Job No. 386-428

RESPONSE TO REVIEW OF GEOTECHNICAL REPORTS
EASTERLY PORTION OF PARCEL 15
PORTUGUESE BEND CLUB
RANCHO PALOS VERDES, CALIFORNIA

Subject: Review of Geotechnical Reports by Moore and
Taber Easterly Portion of Parcel 15,
Portuguese Bend Club

GROSS STABILITY SECTION G-G'

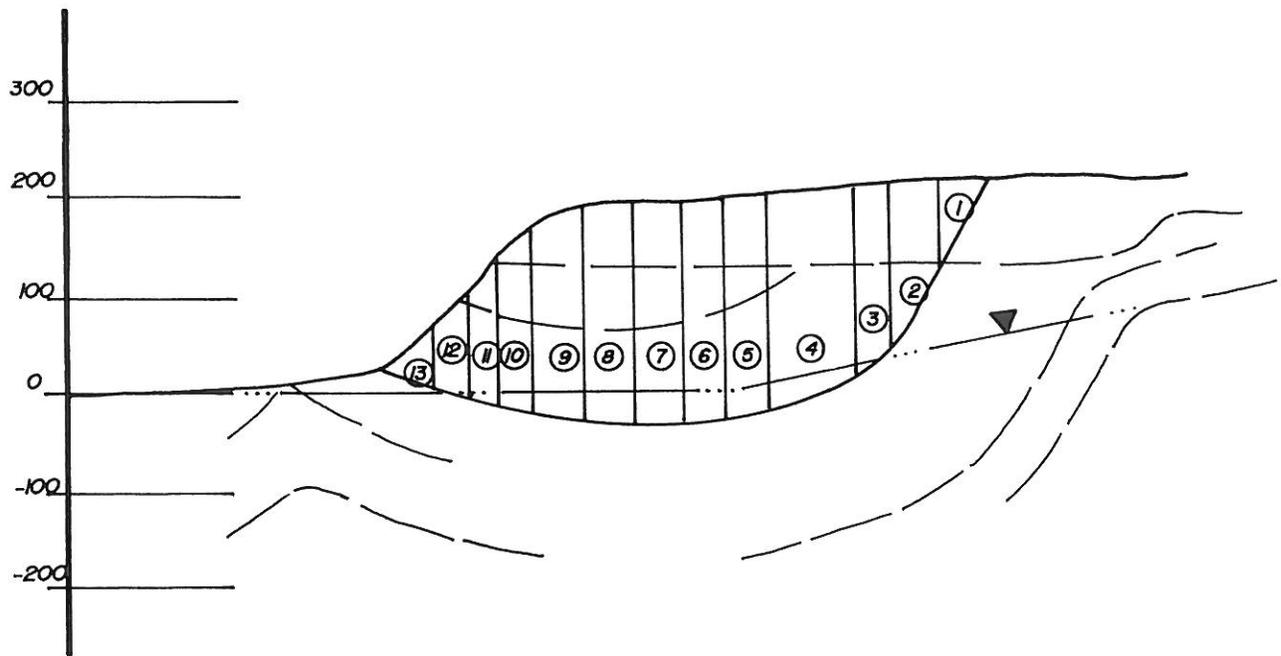
*Assume tan φ for bentonite 1/2
 the value used.
 F.S. 0.846 if tan 16 ÷ 2*

GROSS STABILITY SECTION I-I'

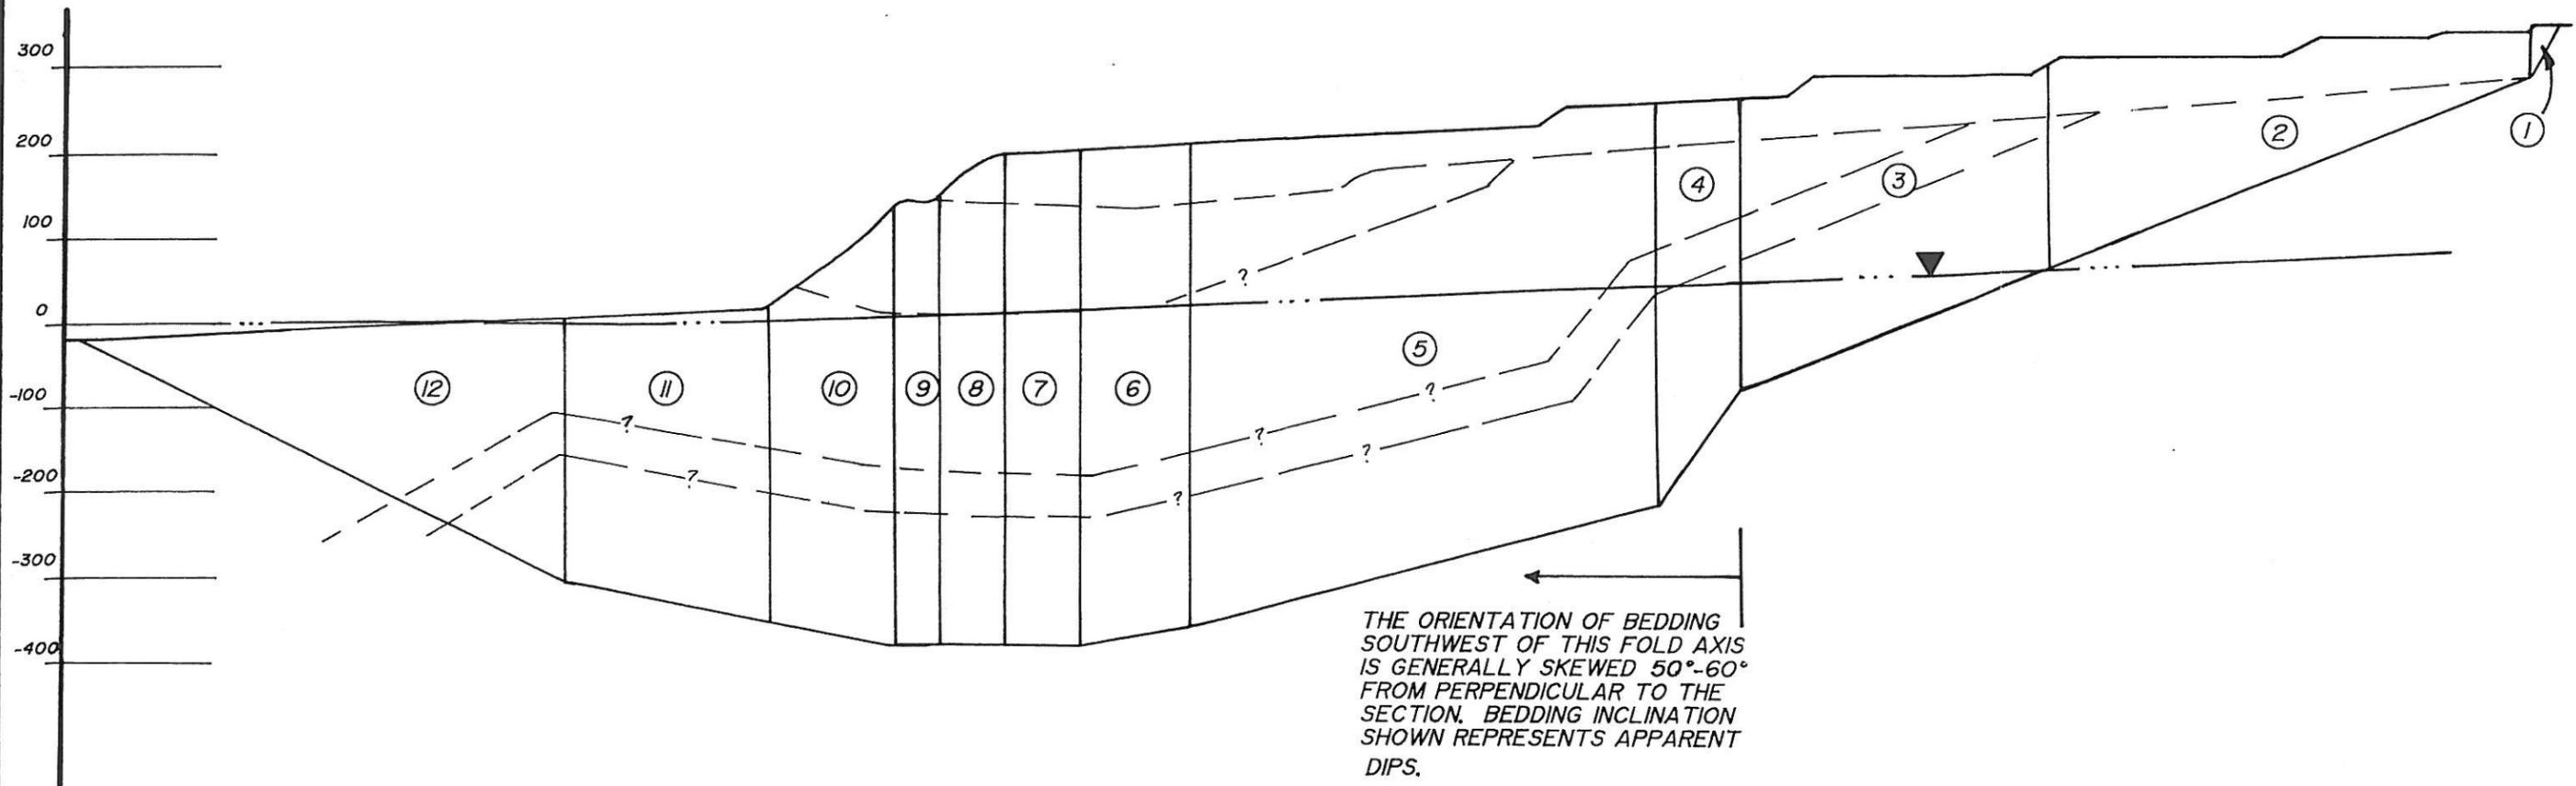
higher values than static

Tan 20° = 2.6 Times Tan 8°

**BLUFF SLOPE STABILITY
SECTION J-J'**

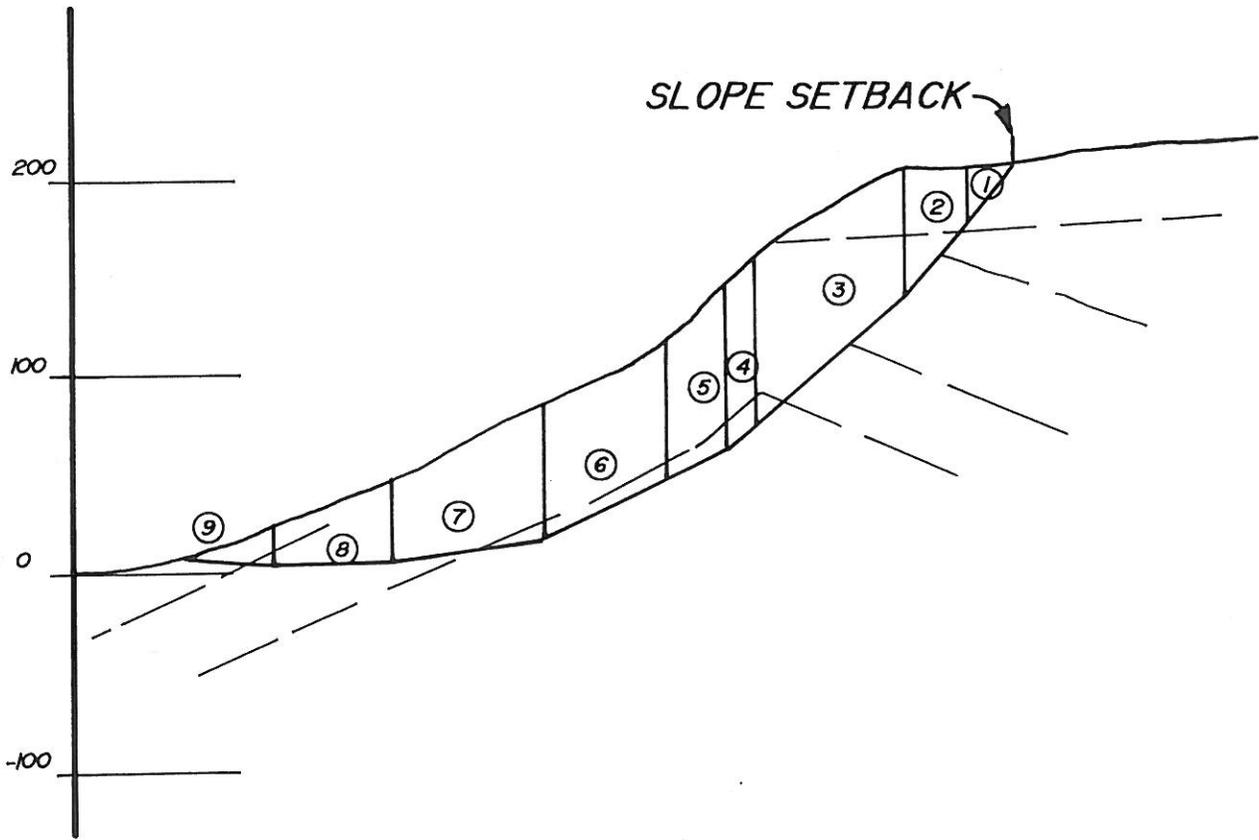
what about jointing
